COMMUNITY DESIGN REVIEW BOARD STAFF REPORT
Meeting Date November 19, 2024

AGENDA ITEM: Design Review Resolution, Birch Run Station, 1715 Beam Avenue East

Engineering Plan Review

Environmental Review

EXTERIOR ELEVATIONS
A-700

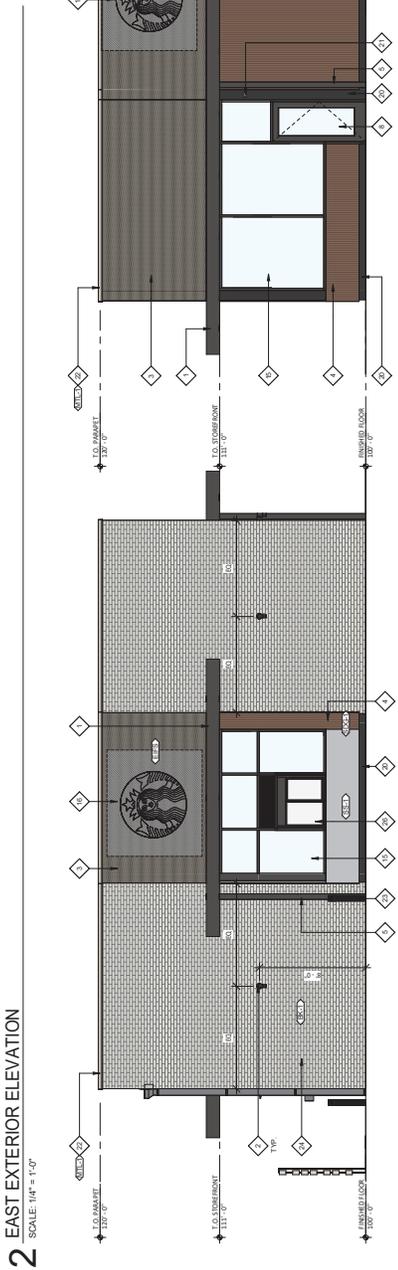
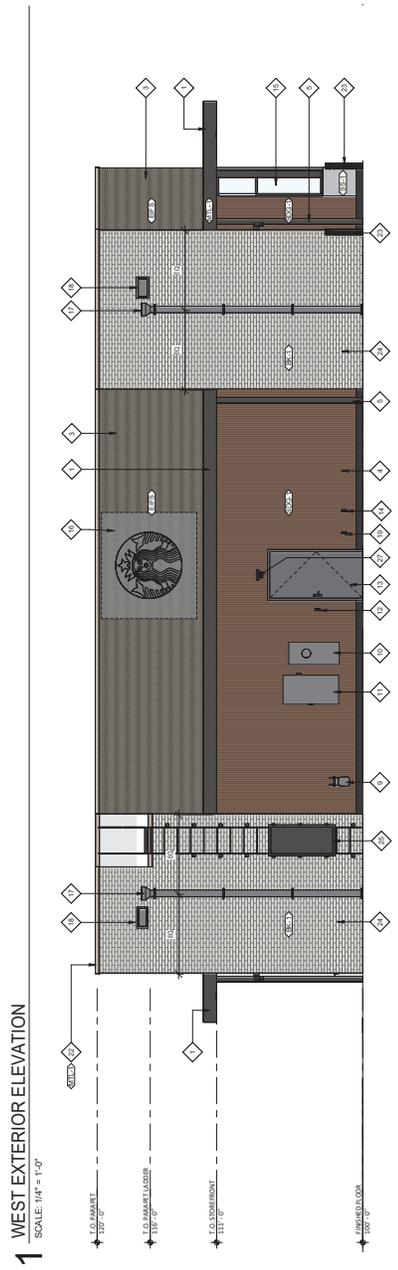
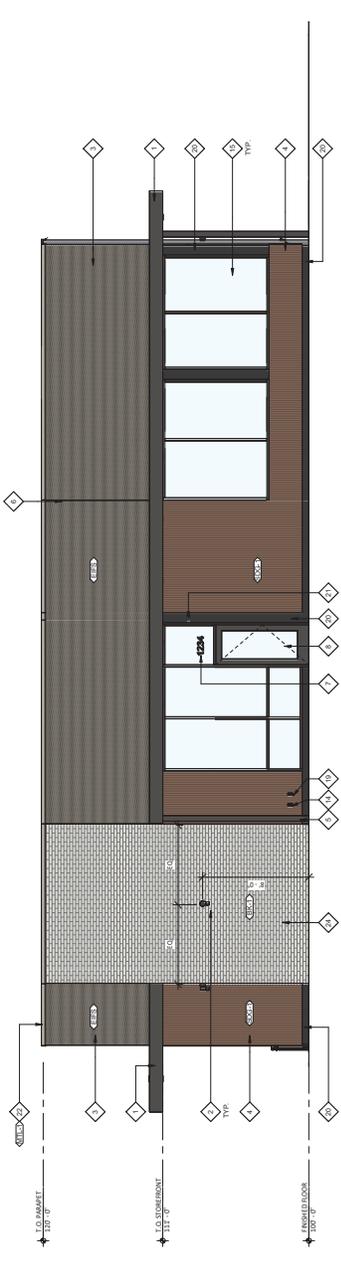
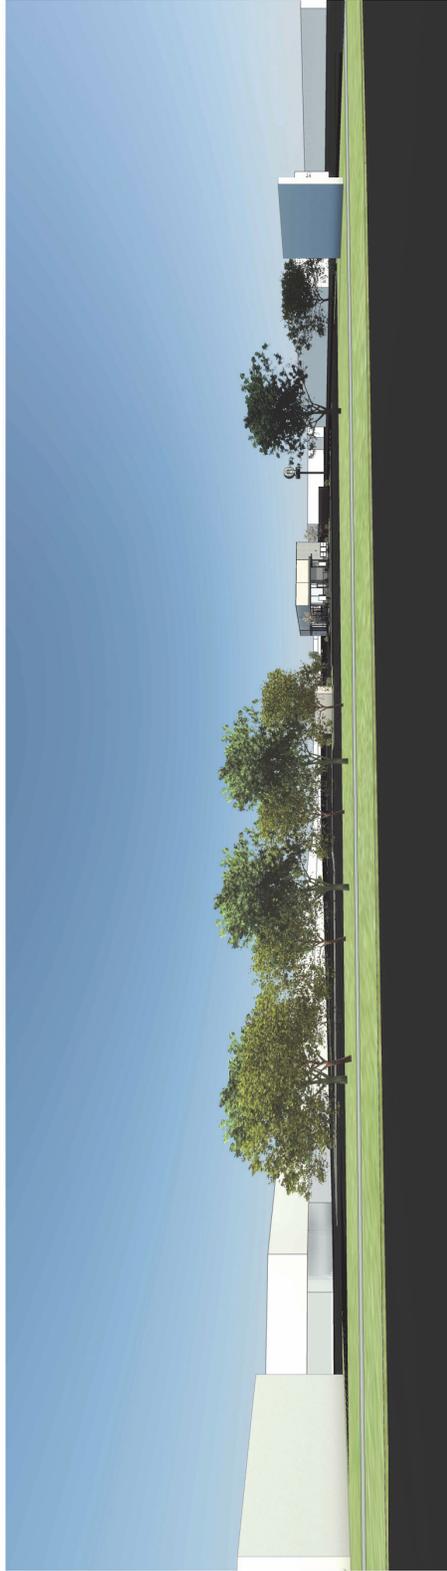
- Buildings fronting neighborhood internal streets are required to have a minimum of two stories.
 - The applicant is proposing a single 20-foot-tall building. Of the 20 feet, the top four feet is dedicated as parapet space to help increase the height of the structure and screen mechanical equipment.
